THIS IS **ONE** SECTION OF **TWENTY TWO,**
THAT FORMS PART OF A LARGER GROUP SUBMISSION
TO THE NEW ENGLAND REZ TRANSMISSION PROJECT
SSI-74175972

GROUP EIS SUBMISSION FOR THE NEW ENGLAND REZ TRANSMISSION PROJECT | SSI-74175972

SECTION 10

Erosion, Sedimentation and Ground Stability

FIGURE 3.29: A-LINE

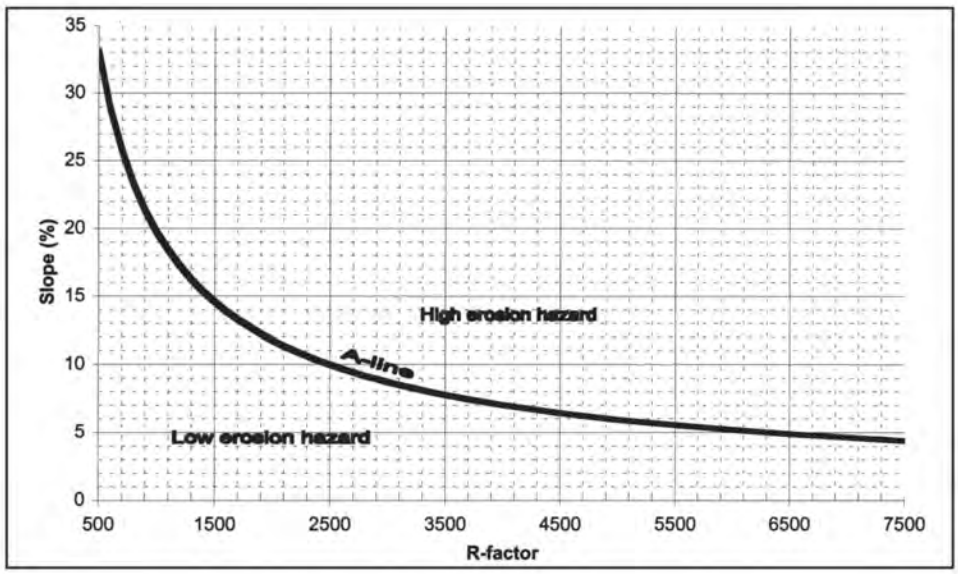
The graph makes the relationship clear. As rainfall erosivity increases, progressively lower slopes are sufficient to place land within the high erosion-hazard category. Conversely, steep slopes can present a high erosion hazard even at considerably lower R-factors.

But EnergyCo does not take the next step. There is no project map showing the relevant slope gradient against the R-factor. There is no map identifying which proposed access tracks, tower sites, cuttings or earthworks fall above the A-line. There is no route-wide map of low and high erosion hazard.

This is the work that Energy Co have not completed. There is much of the project footprint that sits in the "High Erosion Hazard" category.

> Figure 3.31 - **maps rainfall erosivity (R-factor) across the project area.**

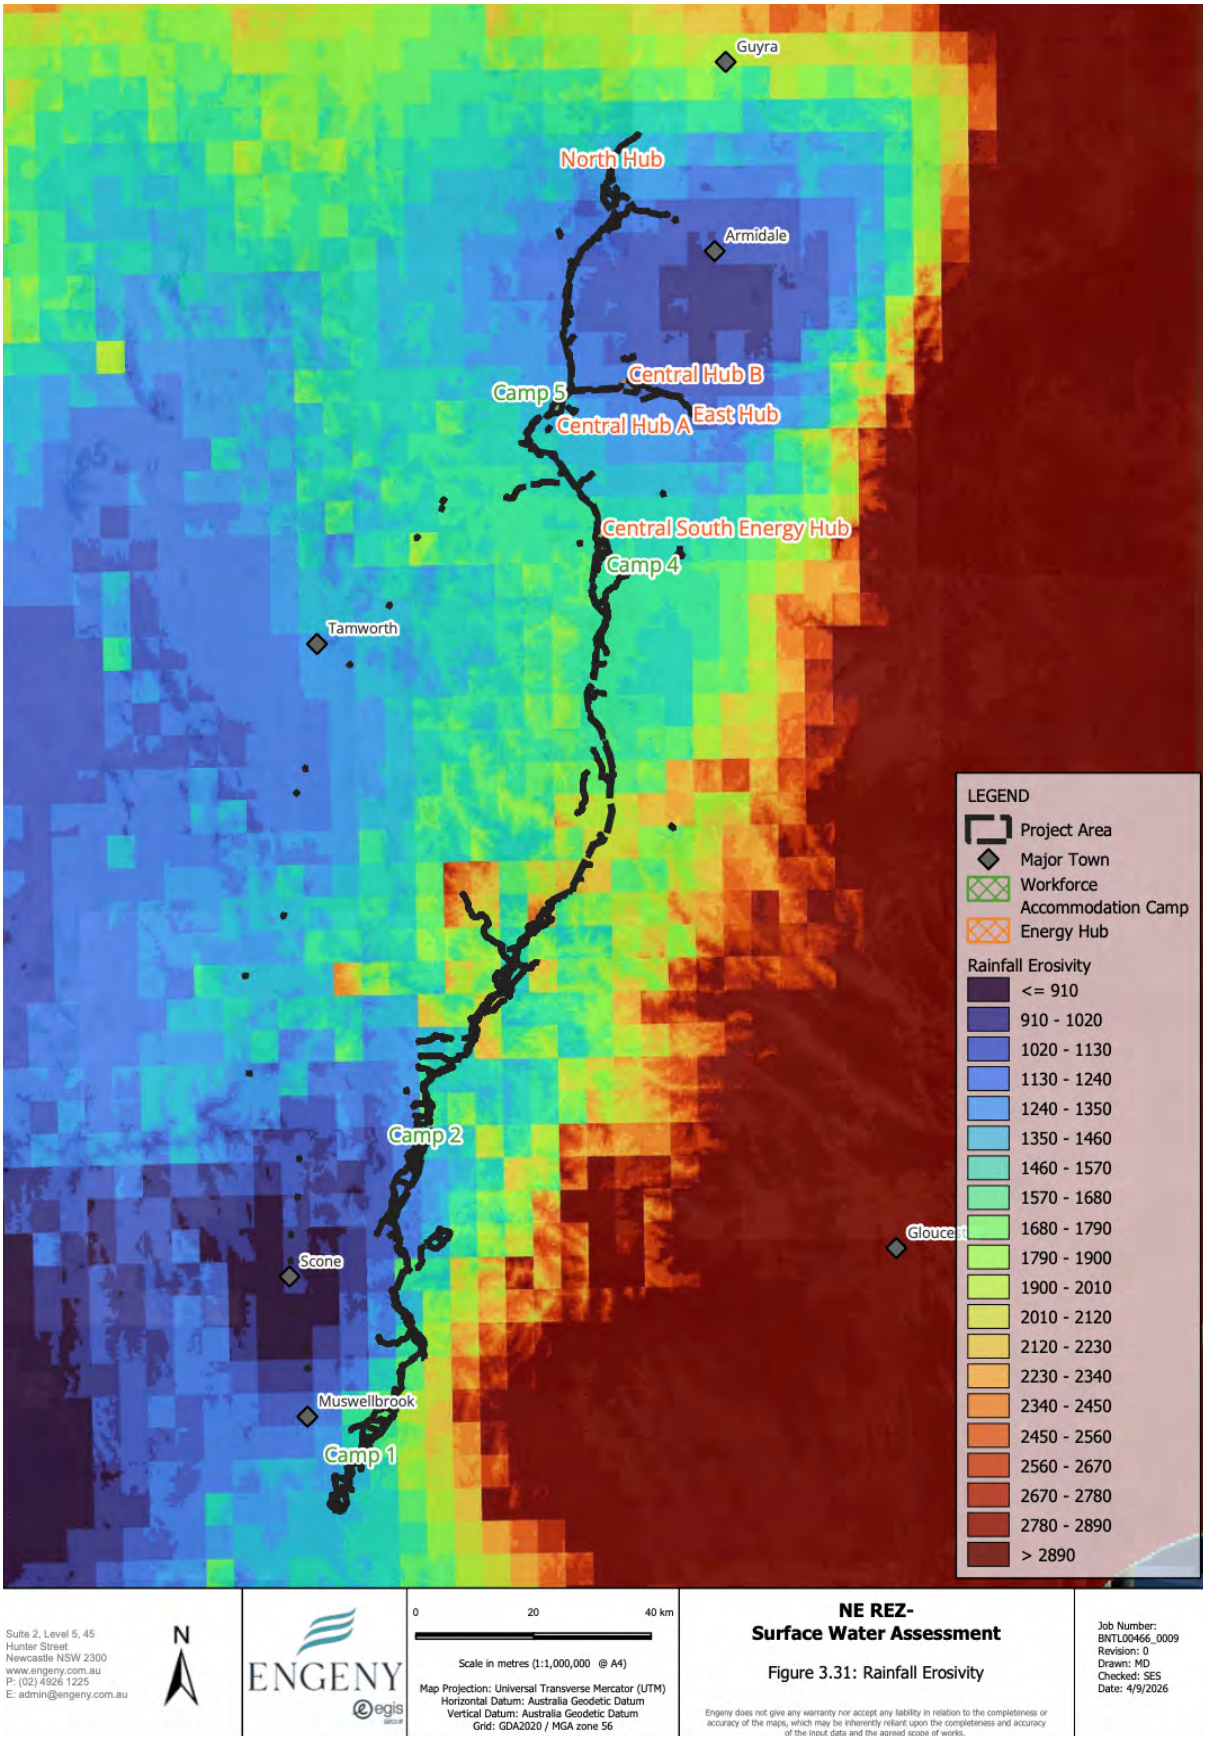
Figure 3.31 shows that some of the highest rainfall erosivity occurs through elevated range country that is also characterised by steep terrain. Under the A-line method, the combination of increasing slope and high rainfall erosivity moves land into the high erosion-hazard category. This makes completion of the project-specific slope assessment particularly important.

Technical Report 14 therefore provides the method and maps the rainfall erosivity, but does not provide the corresponding project-specific slope assessment or the resulting low/high erosion-hazard classification. Nor does it provide the soil-loss classes or estimated soil-loss rates that section 2.3.3.1 says were determined. These are the results needed to understand where the project presents the greatest erosion risk.

> Figure 4 - **LSC Water Erosion hazard along transmission corridor**

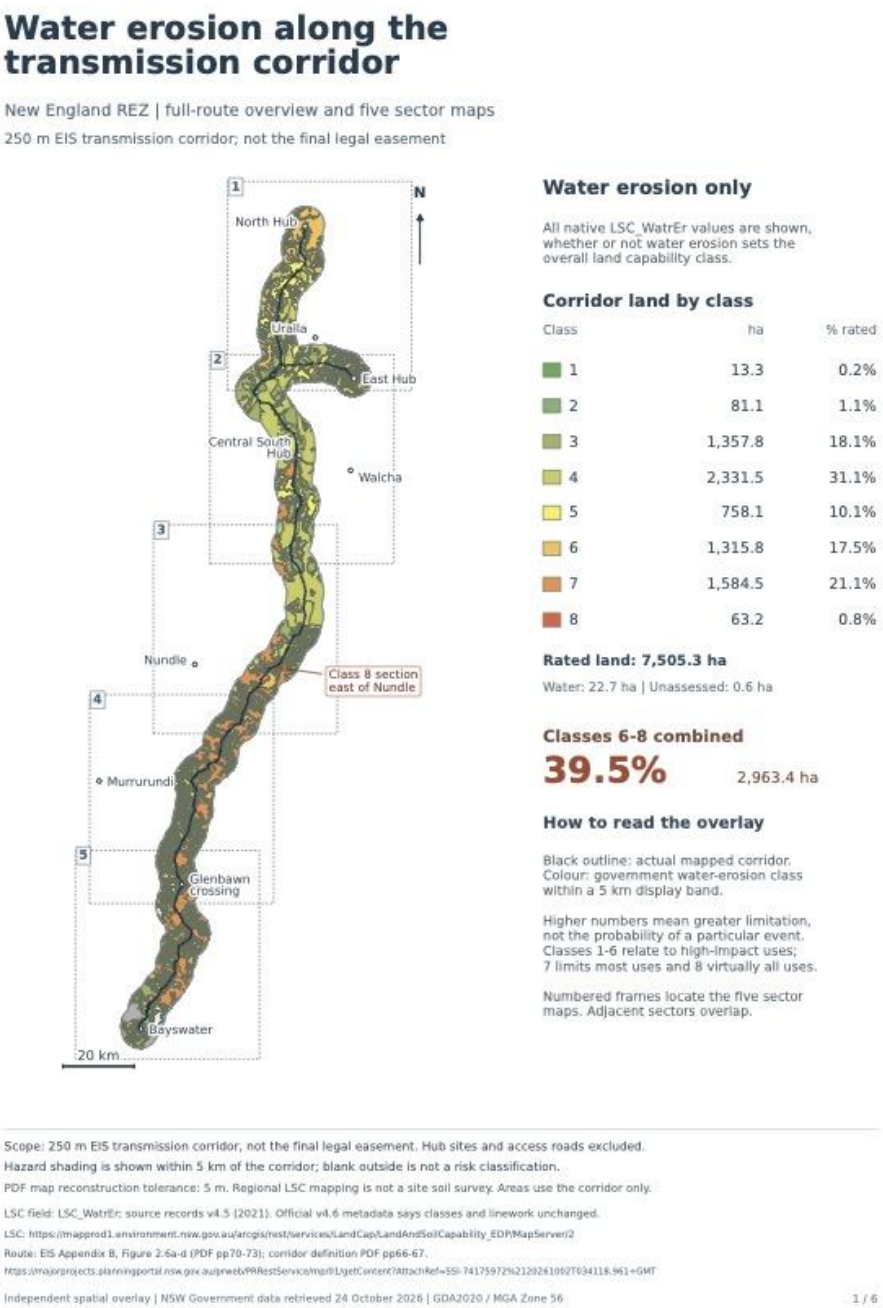
The map shows the NSW Government LSC water-erosion hazard along the published 250 metre EIS transmission corridor. It identifies approximately 39.5 per cent of assessed corridor land within water-erosion Classes 6 to 8.

The map relates only to the published transmission corridor and excludes separately mapped access roads and hub sites.
